Origination Form

Proposed Revisions to a Standard Plans Index

Originator:	Stepp, Richard	Index Number:	536-002
Date:	7/25/2024	Sheet Number(s):	1, 27, 28
E-mail:	richard.stepp@dot.state.fl.us	Index Title:	Guardrail Transitions and Connections for Existing Bridges

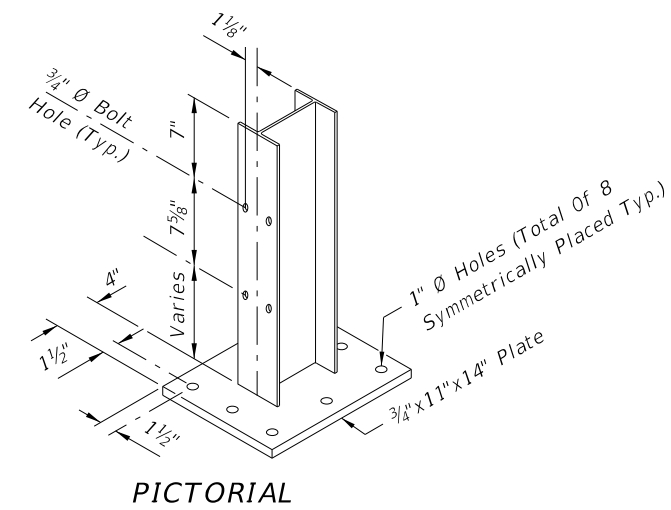
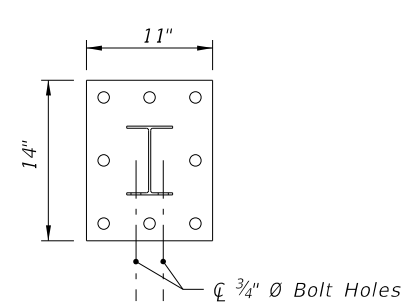
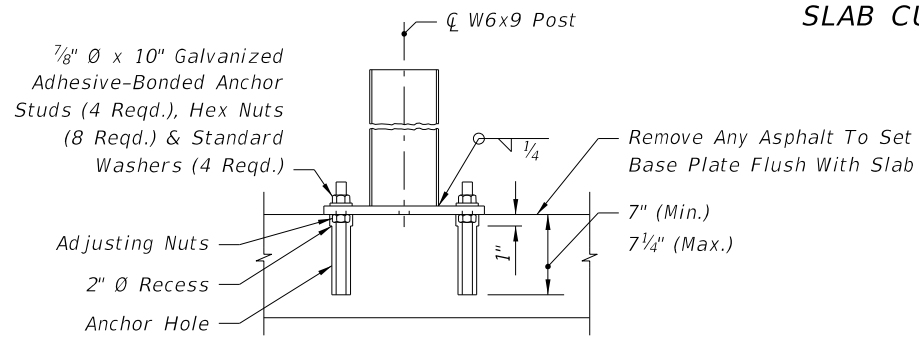
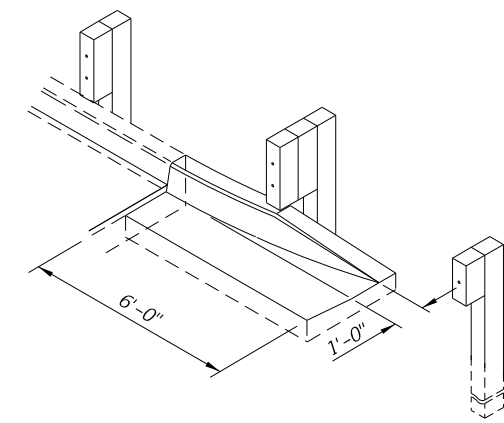
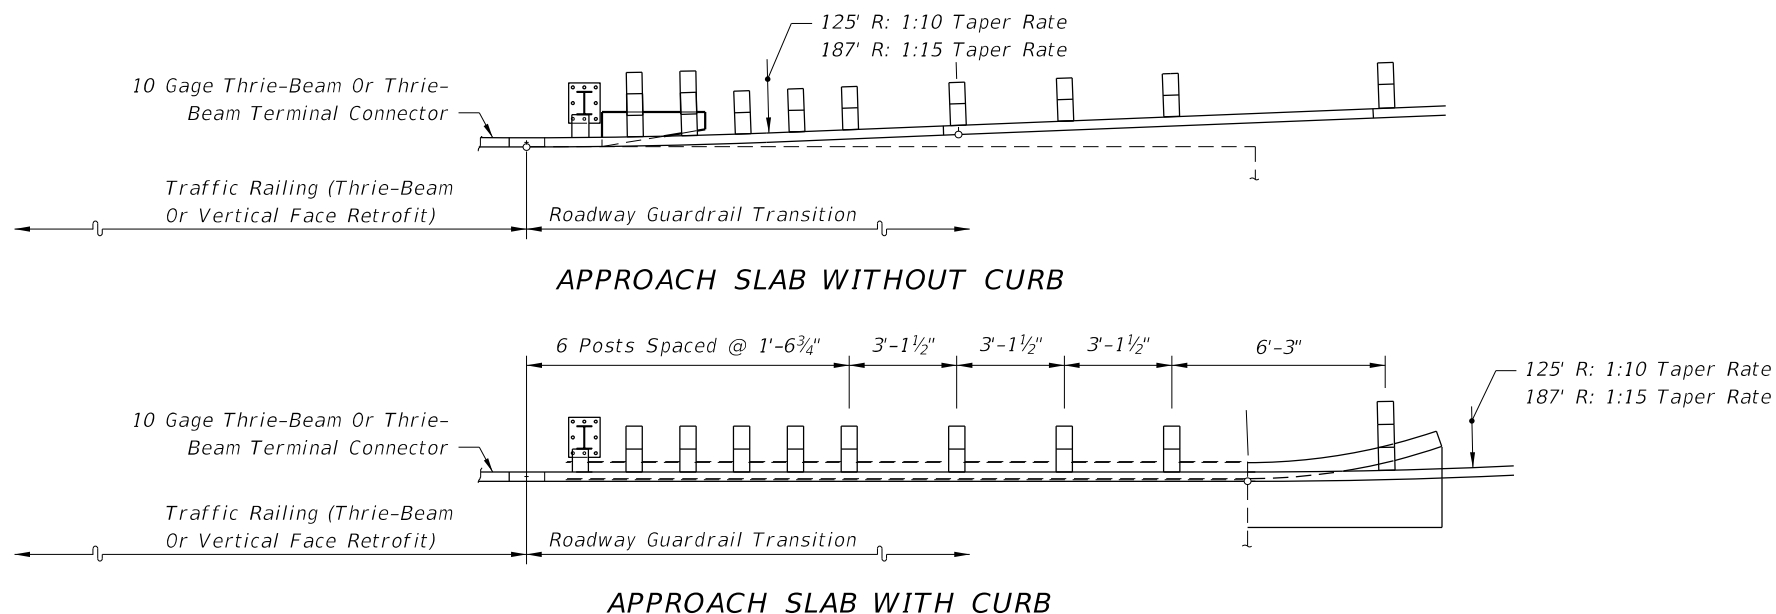
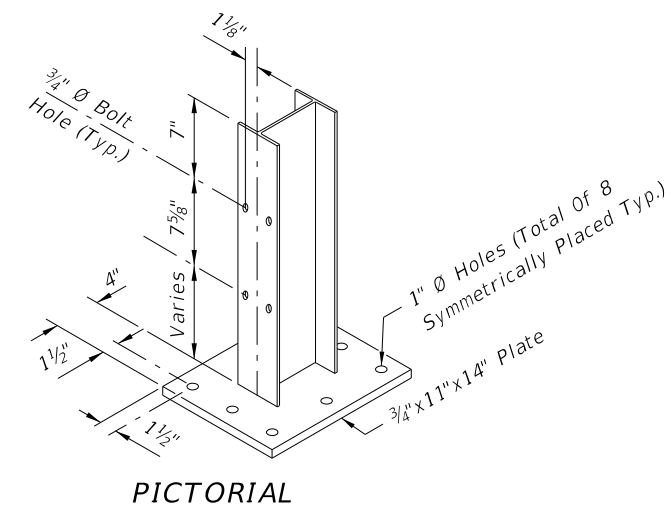
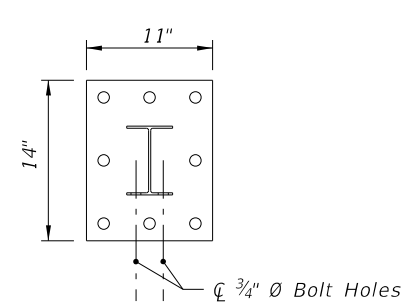
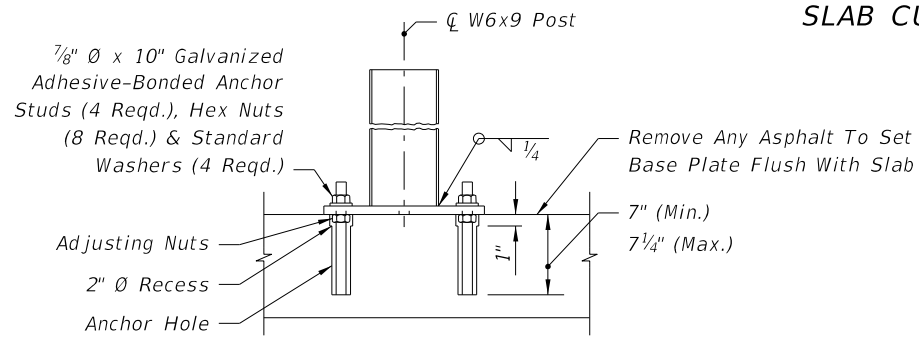
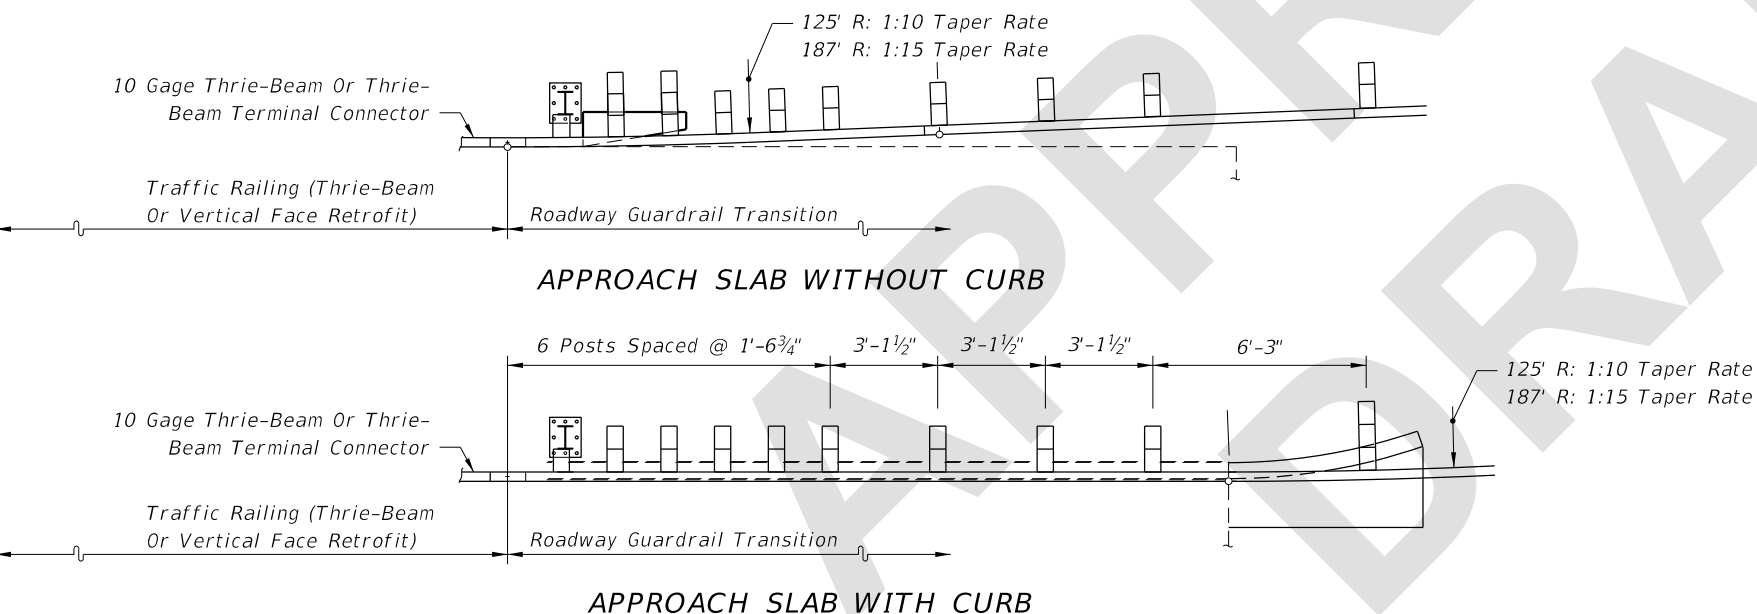
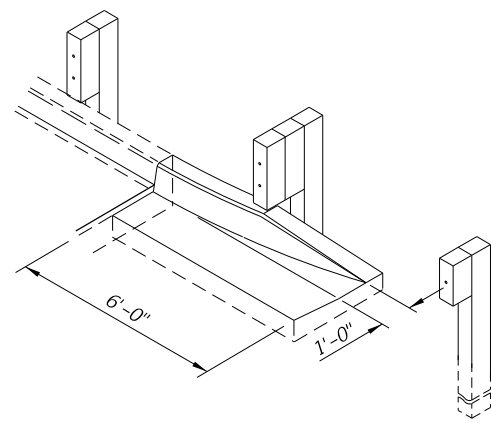
Sheet 1: Added a note explaining required rectangular washer usage to General Note 2.
 Sheet 27: Changed guardrail's longitudinal alignment measurement from the end of concrete from 5 1/4" to 7 1/4" (+/- 2")
 Sheet 28: Changed guardrail's longitudinal alignment measurement from the end of concrete from 5 1/4" to 7 1/4" (+/- 2")

Sheet 1: Contractors questioned if the rectangular washer policy of the referenced Index 536-001 applies, so this added note provides that clarification.
 Sheets 27 & 28: Changed longitudinal dimension to align with crash-tested systems and provide a broader tolerance for placement that follows successful practices in other states.

1. This index provides guardrail transition details for approach and trailing end guardrail connections to existing bridges, including details for connecting to traffic railing retrofits and safety shape barriers on existing bridges. Sheets 1 through 26 apply to bridges with retrofitted traffic railings (Sheet 26 shows the trailing end guardrail connections). Sheets 27 and 28 apply to bridges with safety shape traffic railing, and they provide approach and trailing end transition connection details for guardrail. Construct these guardrail transitions and connections where called for in the plans.
2. For miscellaneous guardrail components and construction details that are not provided in this Index, refer to Index 536-001. Place Rectangular Washers over panel face at Thrie-Beam Terminal Connector splice bolts.
